**RE: Major Site & Subdivision Approval – Subdivision Amendment #5  
Fairway View Village Development (Tax Map 32, Lot 13)  
Fieldside Lane, Wells, Maine**

On behalf of York Building & Design Center, I have enclosed for your review and consideration an updated Plan Set and associated attachments for the above-referenced project. Revisions have been made to both address and modify several of the as-built conditions outlined in the General Note updates approved with Subdivision Amendment #4, which was approved by the Wells Planning Board in February of 2026.

in background of Photo: Joseph Way, Clubhouse and  
community parking lot

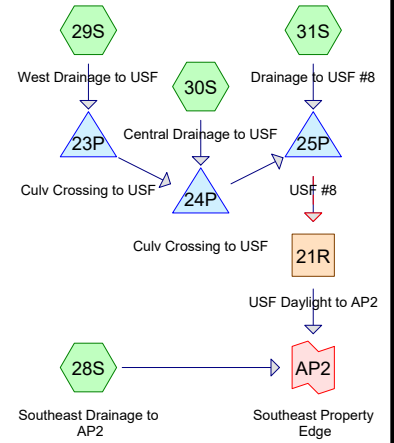
Parking Striping has been completed in the community lot abutting the Clubhouse at the beginning of Joseph Way as required from the original approvals. The Applicant is requesting that all subsequent striping outlined in the original approvals be removed. As a result of this request, several General Notes on Sheet #1 are required to be updated as outlined below:

Carrying these requested changes through the Plan Set, the only resulting change is to Sheet #4 where “No Parking” Signage has been added along the perimeter of the Fire Cistern turnout to satisfy the markings that were depicted with the original approvals.
